TOLEDO - LUCAS COUNTY PLAN COMMISSIONS

REF: PUD-8005-22

SUBJECT: Request for an Amendment to Planned Unit Development, originally granted by Ord.550-12, Ord.87-17 and Ord.30-21, for 75 senior units w/ commercial units at 801 Division Street.

SITE PLAN - NORTH

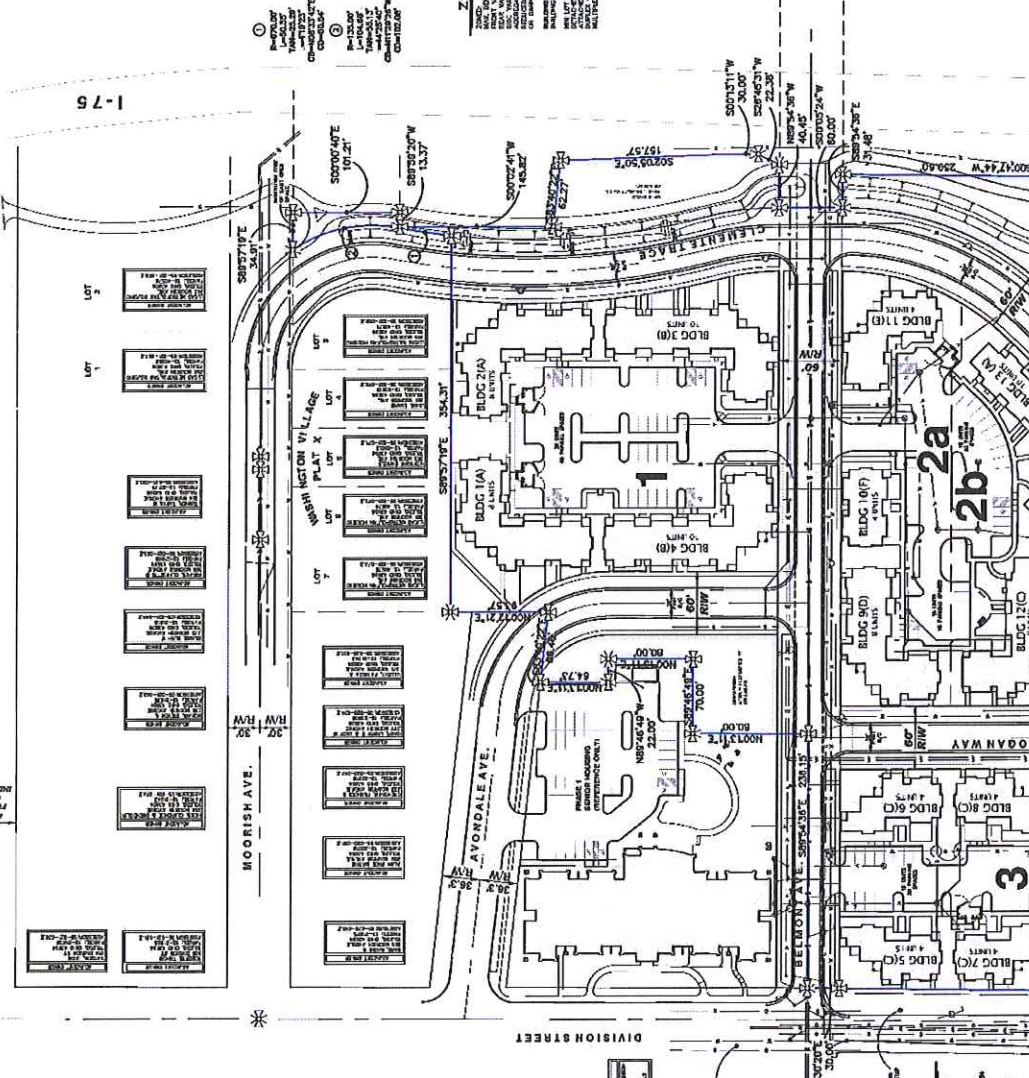
The landscaping plan submitted provided five (5) trees along Division Street, zero (0) trees along Nebraska Avenue and three (3) trees along Rogan Way. The proposed landscaping along the street frontages does not meet the Urban Commercial Landscaping Standards of TMC§1108.0300. Foundation plantings are required for the full street-facing building elevations and landscape areas at major building entrances. Staff recommends an additional two (2) trees be installed along Division Street, seven (7) trees be installed along Nebraska Avenue and six (6) trees installed along Rogan Way. As a condition of approval, a revised landscaping plan shall be submitted with the required number of trees and foundation plantings along each street frontage.

The landscaping plan depicts a solid row of shrubs along the parking lot facing Rogan Way. Additional landscaping is depicted within the interior of the development at building entrances and the parking lot landscape islands in efforts to reduce the impervious surfaces on site. The proposed landscaping for the perimeter and interior parking lot satisfy the requirements of the Urban Commercial Landscaping Standards.

- a. Landscape improvements must be provided in the sidewalk or other paved area in front of a building with tree grates, or other walkable surface material treatment for open tree pits, in the form of one (1) shrub or understory tree for every thirty-feet (30') of lot frontage. **Not acceptable as depicted on landscaping plan. A revised landscaping plan shall be submitted depicting seven (7) trees along Division Street, seven (7) trees along Nebraska Avenue and nine (9) trees are required along Rogan Way, subject to approval by the Plan Director.**

- c. Foundation plantings are required for the full street-facing building elevation; and landscape areas at major building entrances; **not acceptable as depicted on the landscaping plan. Foundation plantings shall be provided for the south building elevation along Nebraska Avenue. A revised landscaping plan shall be submitted depicting additional foundation plantings, subject to approval by the Plan Director.**

BUILDING ELEVATIONS – NORTH & SOUTH

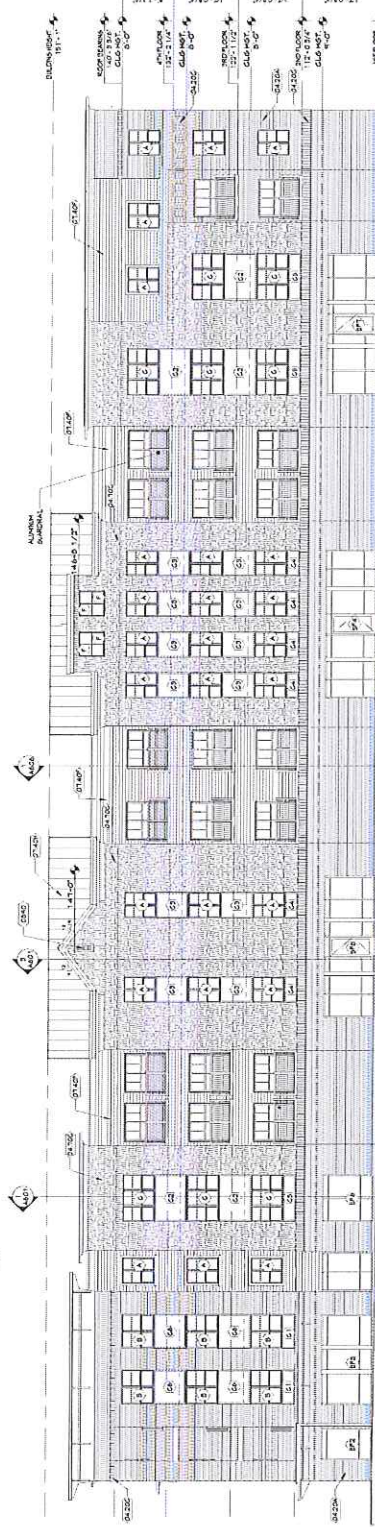
The proposed elevations submitted included the quantity or percentage of the façade materials for the entire building but did not include a breakdown for each side. The materials proposed on the elevations consist of brick veneer (42%), vinyl horizontal siding (35%), stone veneer (15%), fiber cement panel (8%) and glass windows. The elevations indicate brick veneer for a majority of the façades with the exception of the north and east facing elevations where vinyl horizontal siding is predominant and not in compliance with the design standards. As a condition of approval, the applicant shall submit revised building elevations with a breakdown of façade materials for each side of the building that meet the requirements of TMC§1109.0500. Staff recommends the vinyl horizontal siding be reduced and replaced with a higher quality material like brick or stone veneer.

28. The building design shall meet the requirements of TMC§1109.0500 – *Building Façade Materials and Color*. Predominate exterior building materials shall be high-quality materials and must comprise at least eighty percent (80%) of the total wall area of the façade. Predominant building materials include brick, stone, glass, and materials with a brick-like appearance or similar material. Accent building materials may include concrete blocks, vinyl siding, smooth-faced concrete panels or wood sheet goods as a secondary material. Accent materials may not comprise more than 20% of facades visible from the public right-of-way. **Not acceptable as depicted on elevations submitted. Revised building elevations shall be submitted depicting 80% of each façade comprised of exterior building materials in compliance with 1109.0500.**
